Version: EC Comments October 2007

A. Statement of Technical Rationale and Justification

Figure 1 : Illustration of Ambient Altitude and Temperature Conditions

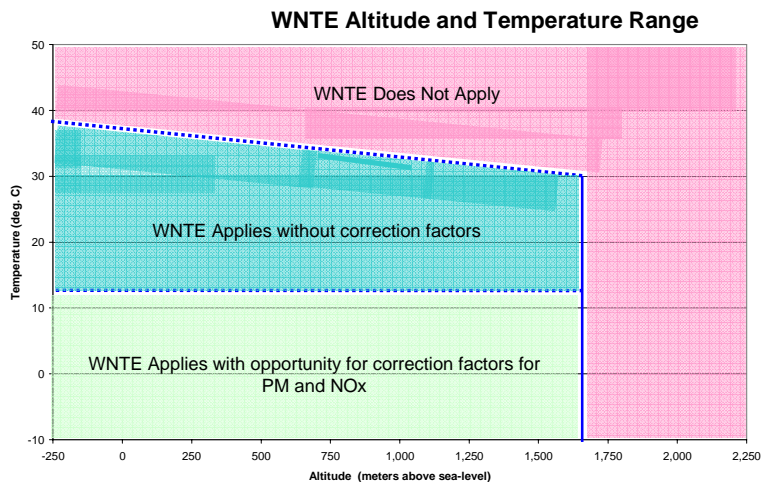
EC Comment: Is chart necessary? – if so needs to be updated so that no correction factors included

Figure 2: Example Not-To-Exceed Control Area When C Speed < 2,400 rpm

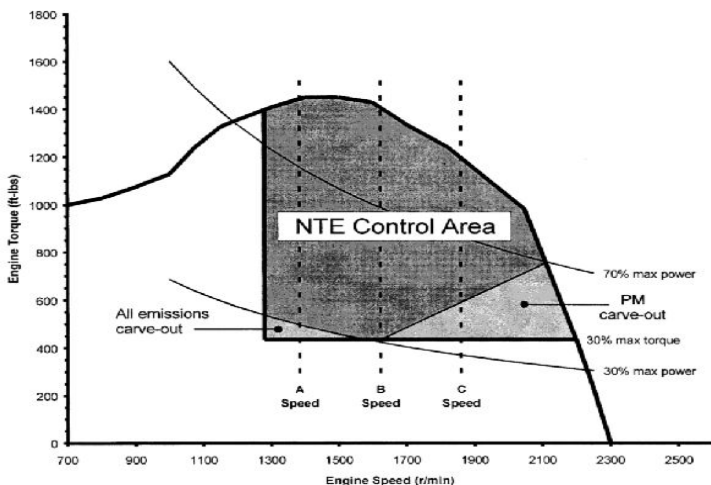
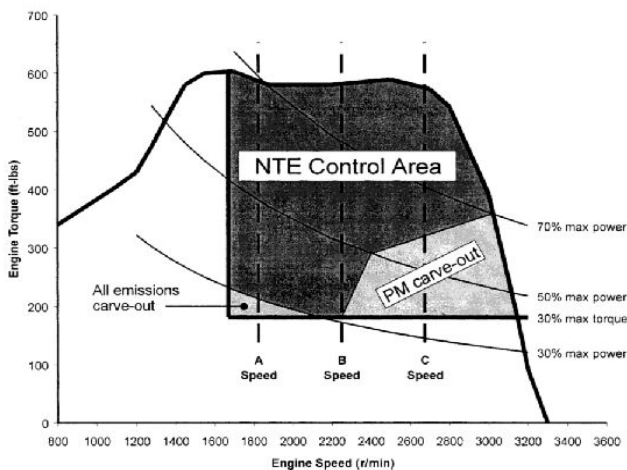
EC Comment: We consider that this text is unnecessary for a GTR and should be removed

Editorial Comment: Will update diagrams to correspond with final control area established in gtr and will add example figures without PM carve out.
